**MOKIHINUI HYDRO PROPOSAL
CONSENT APPLICATIONS
REVIEW OF ASSESSMENT OF ARCHAEOLOGY, CULTURAL
AND HISTORIC EFFECTS**

JULY 2008

Prepared by:
Chris Jacomb
Southern Pacific Archaeological Research
Department of Anthropology
University of Otago
Dunedin

Figure 1. SO 11202 (date unknown) showing "pack track" terminating near Seatonville.

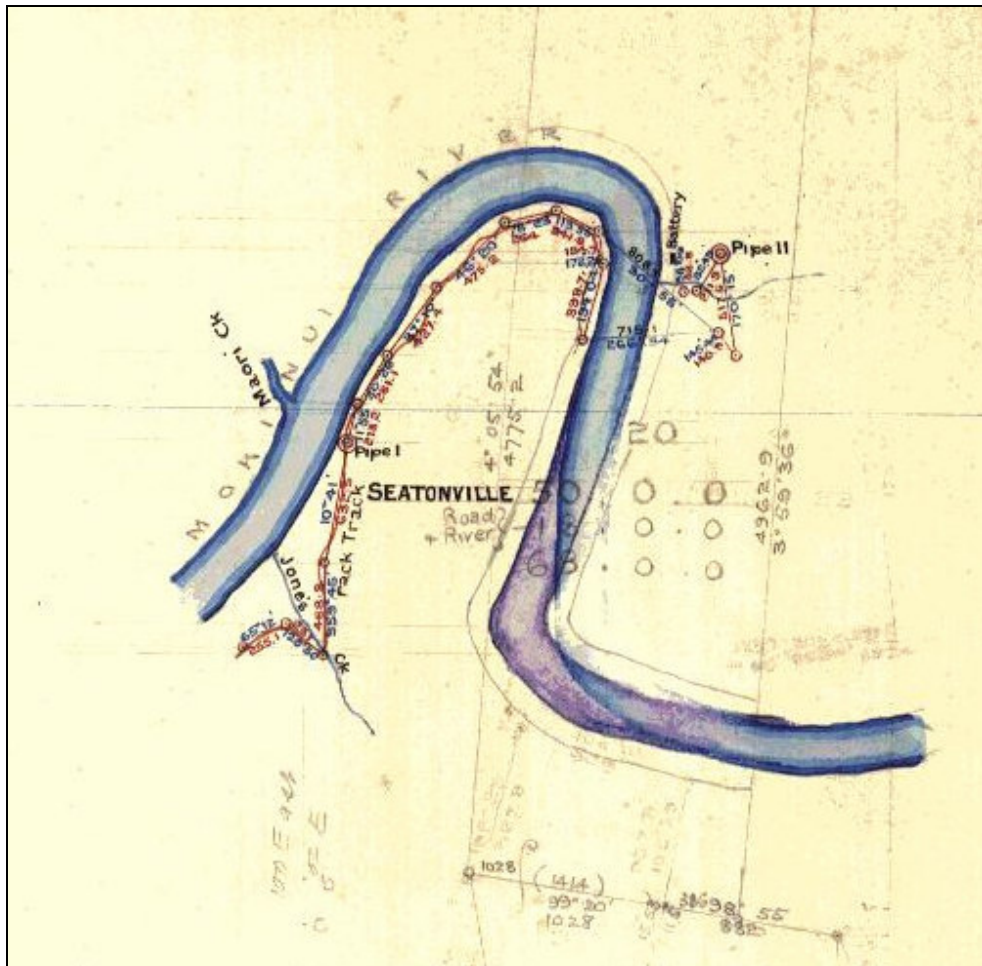
Although little historical research has been undertaken on the pack track, it appears to have three phases of historical activity that contribute to its significance. The first is the stretch from the dam site to Seatonville (between Jones Ck and Specimen Ck) the construction of which began some time after 1867 and which had been completed as far as Coal Creek (about 1 km east of Seddonville) by 1874 (Barr 2007: 13-14). It appears that the first application for a mining license in the vicinity of Seatonville was made in 1873 (Barr 2007: 14) at which time the mine warden noted that, although the ground was rough, a track could be made there. I have done no research myself into the history of the pack track but it seems unlikely that the track would have been formed any further upstream than necessary to service the gold mining operation. Some support for this can be seen in an early but apparently undated survey plan, SO 11202 (Barr: fig. 6, see Figure 1 below). This plan shows a surveyed line labelled "Pack Track" that originates downstream from Seatonville and terminates at the upstream extent of the known historical remains in the Mokihinui Gorge. I will call this Phase 1.

At some time a route was formed to Karamea via the Rough and Tumble Creek. The Iron Bridge was constructed over the Mokihinui River at the confluence to provide access some time around the turn of the century. This use of the track was slightly different from that to Seatonville and may have been intended for wheeled vehicles. I will call this Phase 2, although I am not certain of the chronological relationship with Phase 1.

Finally, there was a less formal track formed up to the Forks. I will call this Phase 3. It may in fact be better described as a "route" and is currently very difficult to follow in places.

According to this information, it is likely that only the stretch of track between the proposed dam site and Seatonville is especially significant historically. According to Mark Pickering's submission and an anecdotal report, this section is in much better condition than is indicated in the Consultant's report. The section from the dam site to the old iron bridge has added importance arising from its dual role in being part the Rough and Tumble Creek track.
